EPA'S PROPOSED REGULATIONS ON HAZARDOUS AIR POLLUTANTS FROM BOILERS

A Critique of Exaggerated Industry Cost Estimates

Prepared by the
National Association of Clean Air Agencies
December 8, 2010

Figure 1. Carbon Monoxide Emissions from Pulverized Coal-fired Boilers

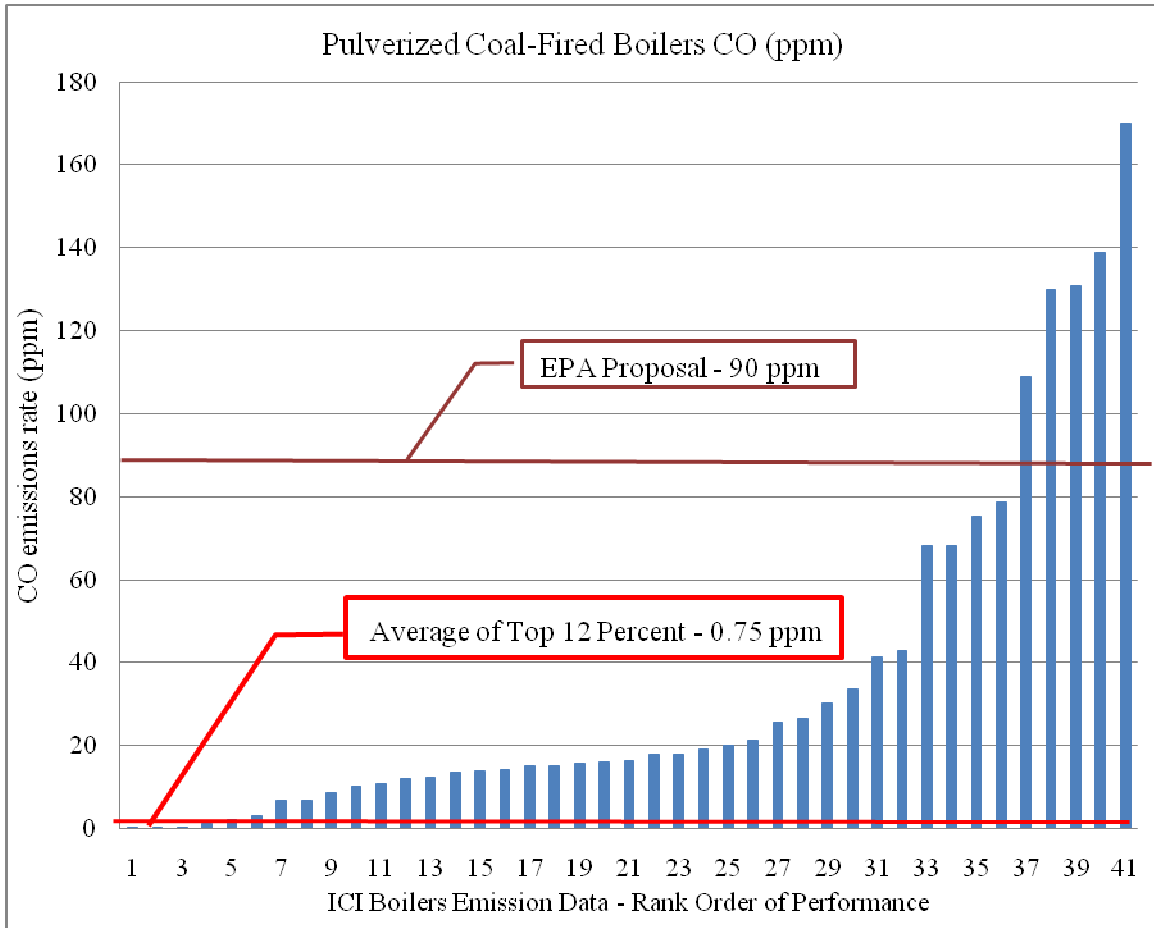
Figure 1 includes all the tested carbon monoxide (“CO”) emission levels for pulverized coal-fired boilers in the EPA database for that subcategory. In this subcategory the arithmetic average of the test results for the best performing 12 percent is less than 1 ppm. By applying a series of “variability factors” (including some questionable factors), EPA inflates the average of the best performing 12 percent and proposes a standard of 90 ppm. The result is that 87 percent of units for which EPA has data already meet the proposed limit of 90 ppm for CO – clearly a lenient standard. There are a total of 187 units in the subcategory. The CIBO/IHS estimate assumes that none of the 146 units in the subcategory that have not been tested will meet the proposed limit and that each unit will require substantial capital expenditures to meet the proposed limit. For this reason CIBO/IHS assumes that the rule will impose capital costs for CO catalysts or new burners for 151 of the 187 units in this subcategory. However, since EPA has robust data for almost 25 percent of the units in the subcategory, a more reasonable assumption is that the emissions profile of the “unknown” universe of sources is similar to that of the “known” universe. Thus, the more reasonable estimate is that 25 -

50¹⁸ of the units in the subcategory – not 151 – will need to reduce emissions.¹⁹ Moreover, especially for pulverized coal sources, combustion efficiency improvements are a far more likely means of compliance than CO catalysts. Thus, the CIBO/IHS “worst case” estimate for direct cost for this item is several times higher than would be anticipated based on the existing data.

Figure 2. Mercury Emissions for Coal-fired Boilers

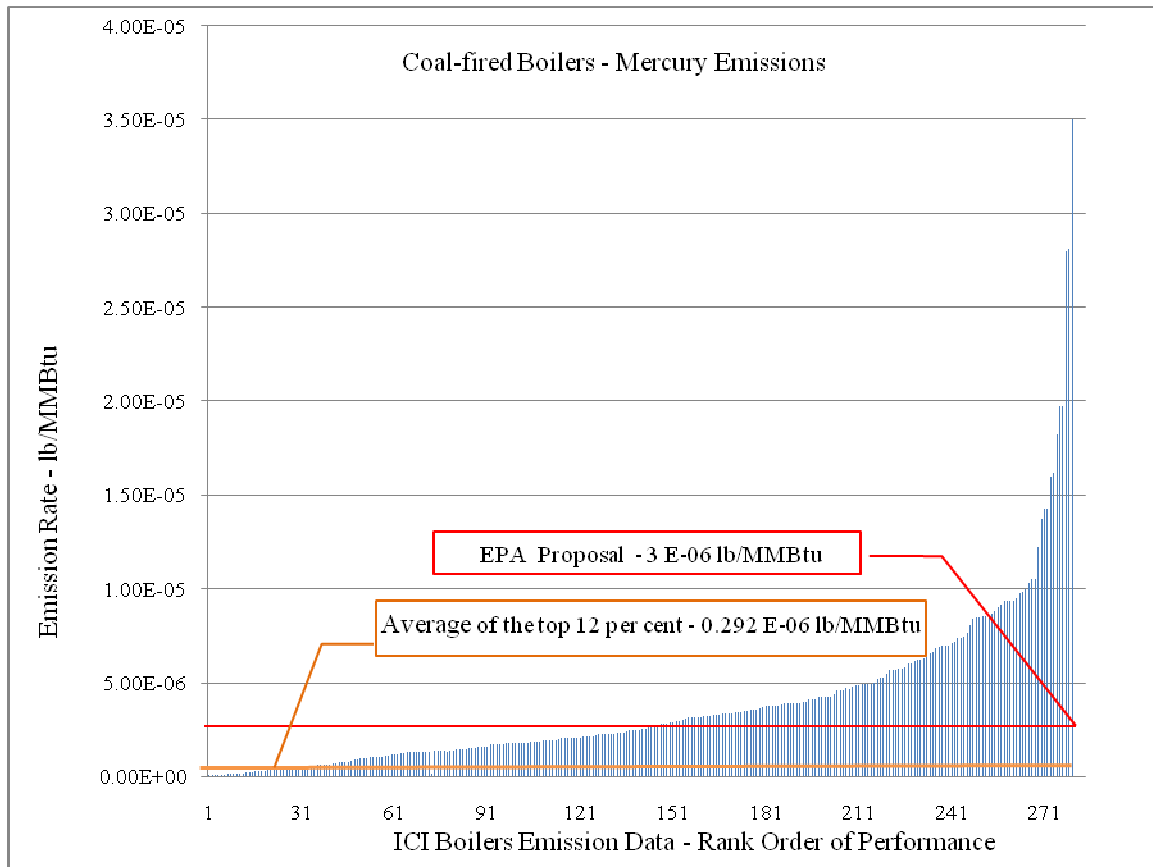
Figure 2 sets out the data²⁰ underlying EPA’s proposal for mercury levels for coal-fired boilers. The average of the test results for the top 12 percent of the units in the subcategory is 0.292×10^{-6} lb/MMBtu. EPA’s several “variability” factors²¹ lead it to

propose a limit of 3×10^{-6} lb/MMBtu.²² This limit is already met by approximately half of the existing sources, with numerous other sources close to that limit. Thus, it would be reasonable to assume that approximately half of the 578 sources within the subcategory will not incur any additional costs and that many of the sources whose emissions are only slightly above the standard²³ will not need to incur major capital costs²⁴. Again, the CIBO/IHS estimate assumes that (1) each of the sources whose test results are above the proposed limit (even by as little as 0.0000001 lb/MMBtu) and (2) each of the 304 sources whose mercury emissions have not yet been measured emits at levels so far above the standard that the capital costs associated with a fabric filter and carbon injection will be incurred. Thus, it is more reasonable to assume that only 33-40 percent of the units (or fewer) within this subcategory will incur capital costs to comply with this proposed limit, not the 75 percent assumed by CIBO/IHS. For these reasons the CIBO/IHS “beyond worst case” estimate for this subcategory is at least two to four times larger than the EPA test data would indicate.
